**Addendum No. 01**

**File Reference Number: RFP 2025 036**

**Title: Englehart and Cochrane Station Upgrades**

**RE: Clarifications/Questions**

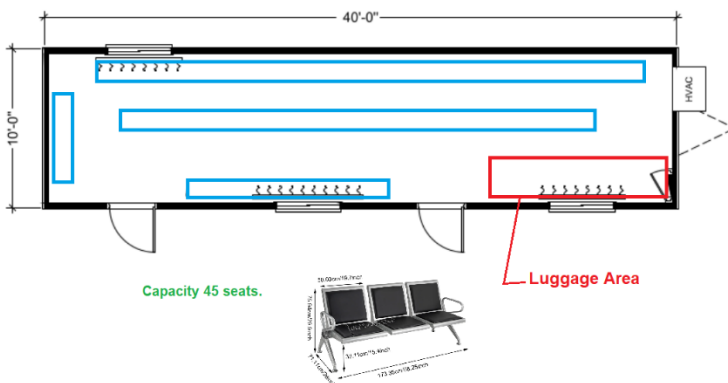
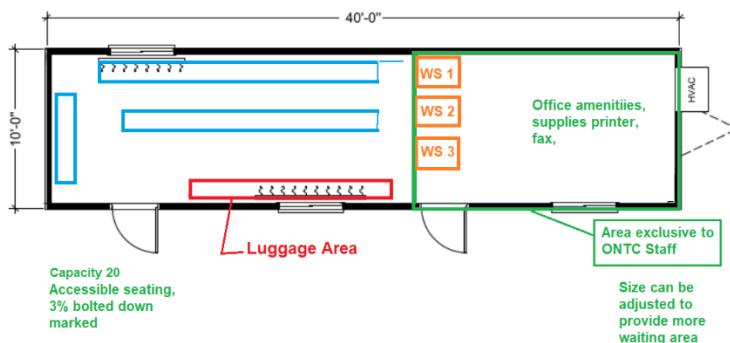
**Item 1:** Please confirm the temporary facility occupancy for Cochrane. Please confirm how many of these people will be staff vs. passengers. Please confirm if the occupancy load will change from the summer to winter months.

**Answer:** Staff: 3-4 persons, only 3 workstations required. Passengers: Up to 75. See below sketch.

Trailer shall be equipped with:

- Water cooler
- Cameras
- Garbage Cans
- IT for Cameras, work stations, ATM
- Display TVs

Accessible (proper signage)  
Ramp or Chair lift  
Door Opener

NB: 4 work stations  
Cochrane: 3 WS

The main working trailer with the workstations must be accessible. This shall be by means of a ramp or a lift. The other trailer does not need to be accessible by ramp or lift. The occupancy load is expected to change from the summer to the winter months, as more people will seek shelter from cold weather; however, the contractor shall price the temporary trailers that will accommodate the expected occupancy load for the entire duration of the construction.

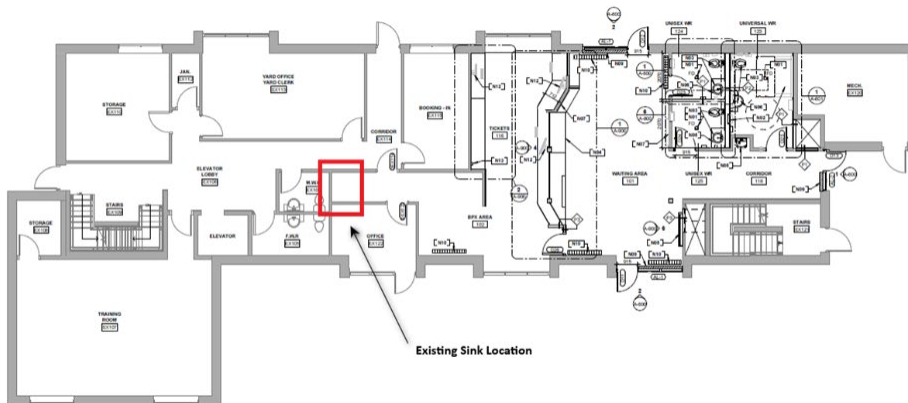
**Item 2:** Can the temporary facilities remain in the parking lots during the construction. If not, please confirm if there is a designated area ONTC had in mind for Cochrane.

**Answer:** The temporary facilities can remain in the parking lots during the construction. Trailers shall be placed along the parking lot in front of the hotel area. See sketch below.
